PETITION NO: Z-24

PROPOSED USE: Single-Family
Subdivision

APPLICANT: Pulte Home Corporation

Applicant is requesting to rezone the property to the R-15/OSC category for the development of a 69-lot residential subdivision. The revised site plan received June 16, 2011 indicates that 11.09 acres (or 35%) of the tract has been set aside as open space for the proposed development. The houses for the proposed development will be comprised of traditional, detached single-family homes, with a minimum house size of 2,000 square feet. The proposal also indicates that a recreation/amenity area may be determined later by the developer. The plan also indicates a 40-foot open space area around the exterior boundaries of the subject property.

REVISED
 RECEIVED
 JUN 16 2011
 COBB CO COMM DEV AGENCY
 ZONING DIVISION
JWC 8-20

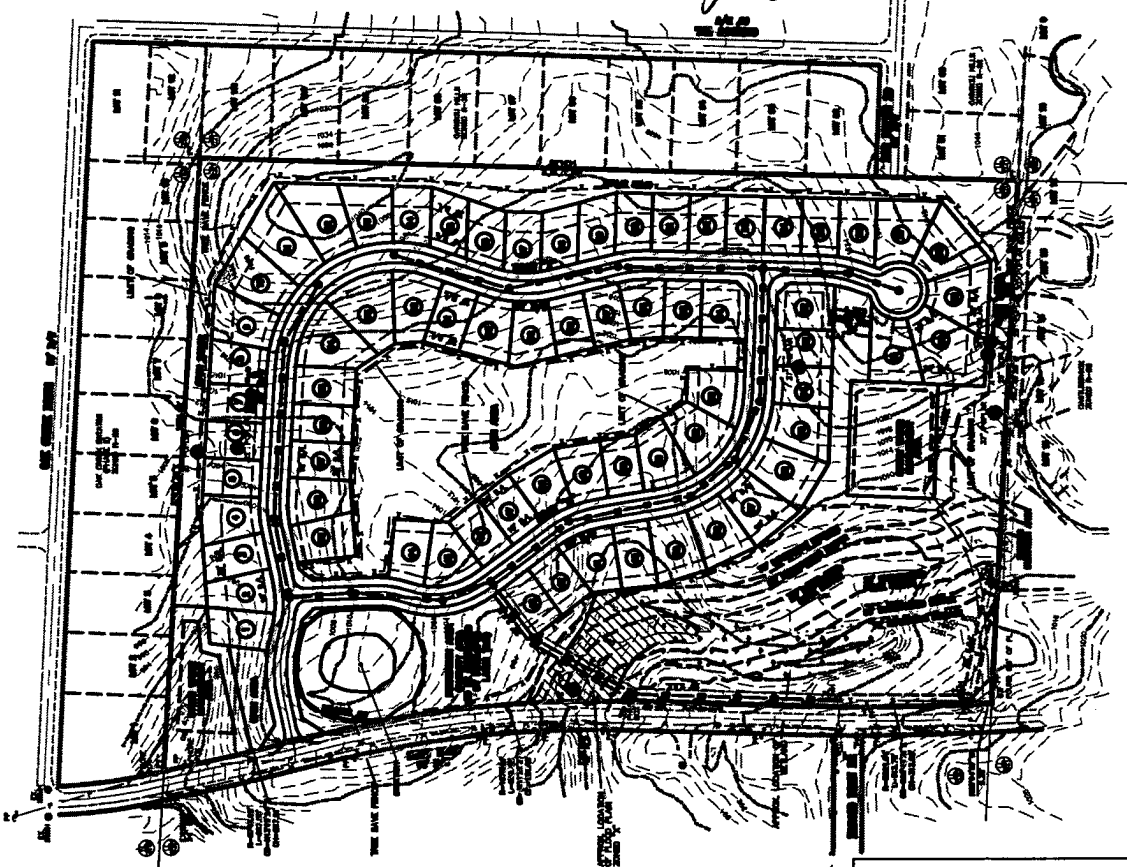
1. Both detention ponds must be located on separate parcels with adequate direct access from the public right-of-way. The northern most detention pond is located directly adjacent to a neighboring existing residential subdivision. Adequate landscaping must be provided to screen this pond from the existing residences.

4. Stormwater management areas need to be identified as structural or non-structural. If stormwater management area is structural then it can not be calculated within open space and be subtracted from total open space area.

5. Wetlands can only account for 75% of required open space. The total wetland area is approximately 8% of required open space so entire wetland area can be calculated within open space. Because Floodplain is Zone X or 500 yr floodplain there is no need to include it as part of the 75% requirement.
